**SITE PLAN OR ZONING REFERRAL TO COUNTY OF ERIE, NY
AND REPLY TO MUNICIPALITY**

Zoning Board of Appeals Application Form

Re: Maintenance building for 431 Willardshire Rd.

PROPOSED ACCESSORY STRUCTURE FOR:
"THE ORCHARD HOUSE"
 431 WILLIARDSHIRE RD.
 EAST AURORA, NEW YORK

PROPOSED SHOP BLDG.

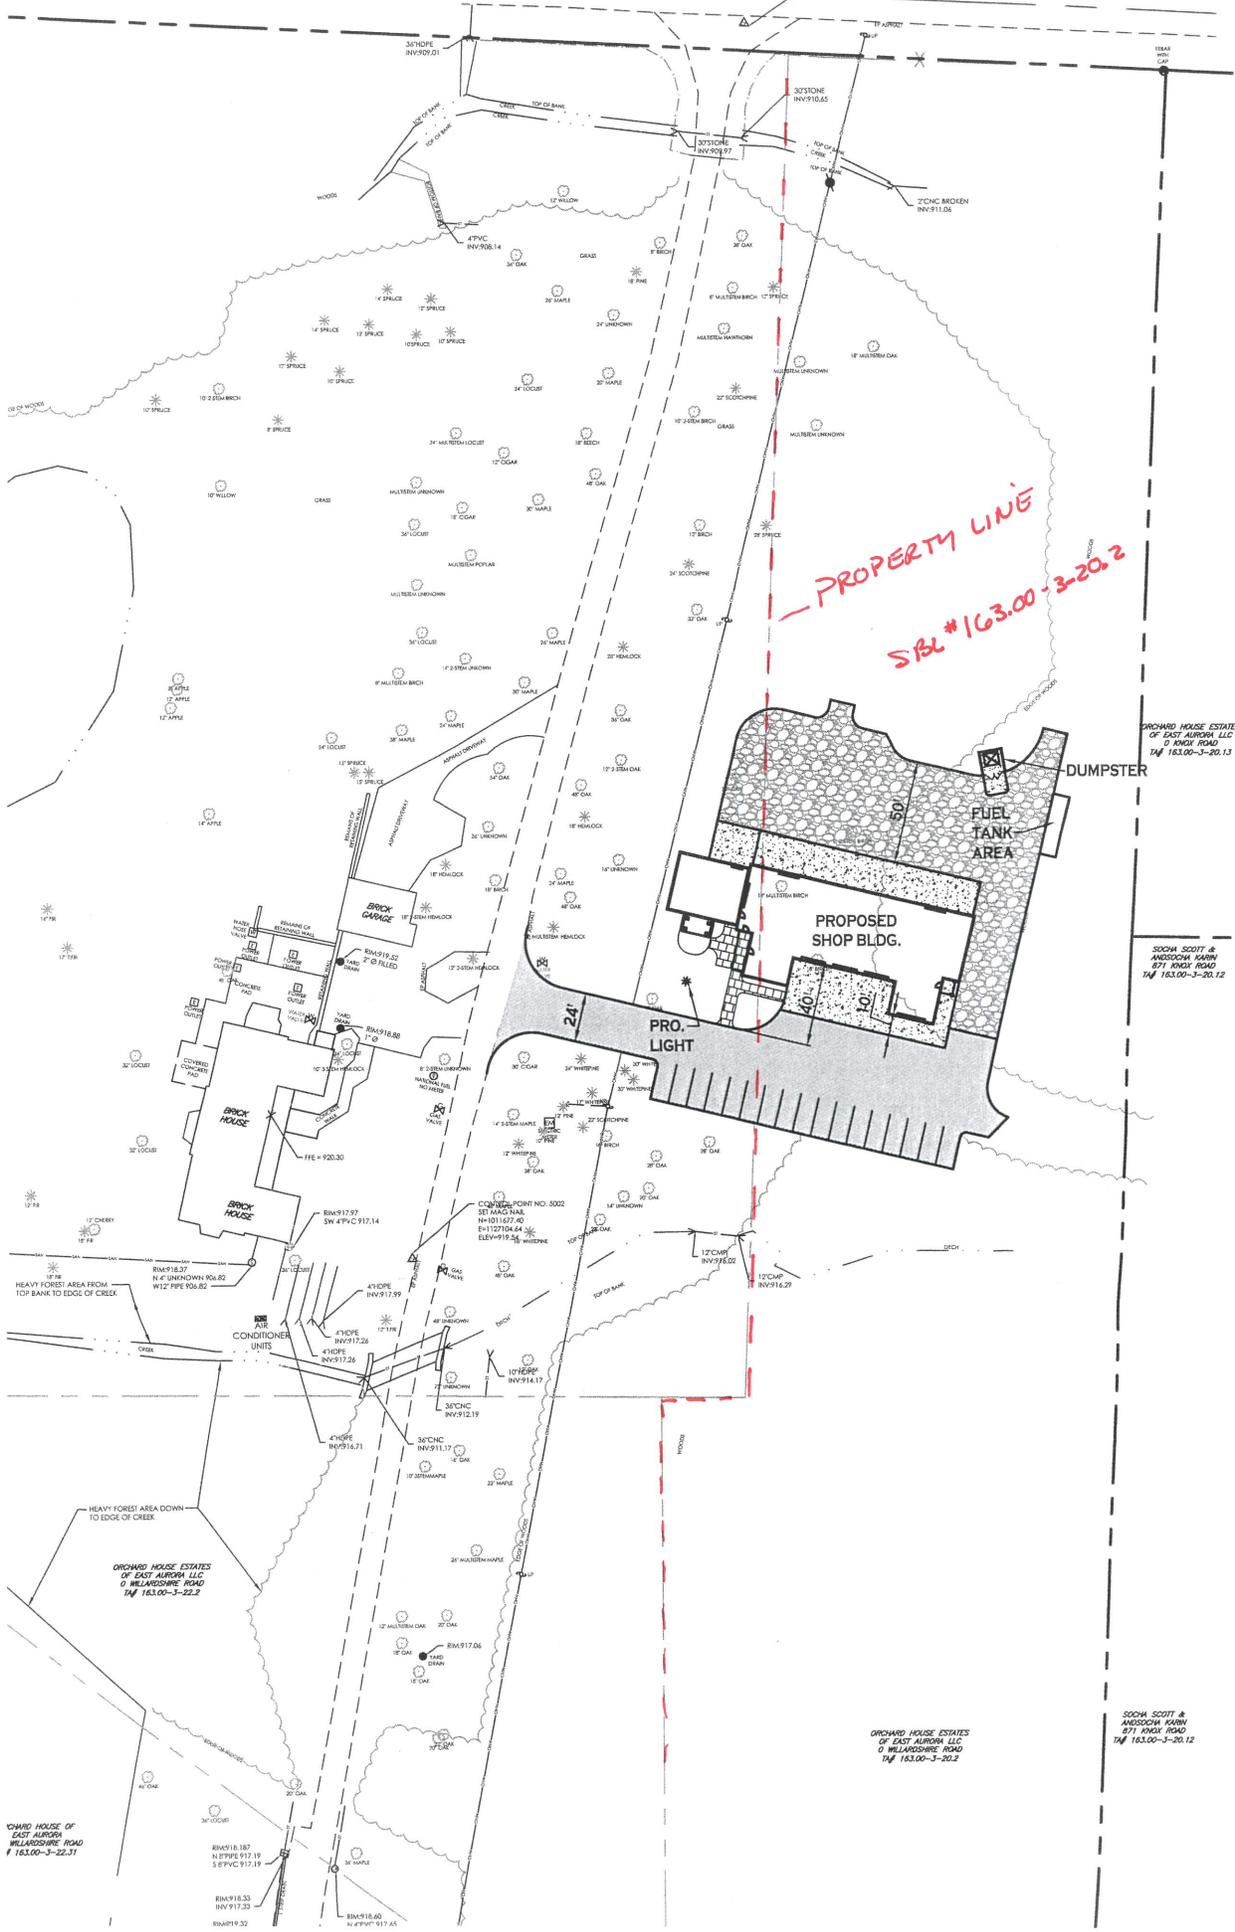
116-8.5C(2) 431 Willardshire
Required: Accessory buildings not to exceed 20' mean height
Requested: 20'3" mean height
Variance required: 3" height variance.

116-8.5F(2) 431 Willardshire
Required: No Accessory building shall be erected in the front yard.
Request: An accessory building in the front yard.
Variance: An accessory building in the front yard.

116-8.5G(1) SBL 163.00-3-20.2
Required: Principal building side yard a minimum of 40'
Request: 0' side yard
Variance: 40'

116-8.5G(2) 431 Willardshire
Required: Accessory building side yard a distance equal to the mean hgt. of the building.
Request: 0' side yard
Variance: 20'3"

Because this building is actually being built on two separate parcels of land the Zoning Board of appeals would also be required to grant a zero lot line variance

for the building on both parcels. To simplify this situation you may want to consider combining the two parcels and thus eliminate the need for the side yard setback variance.
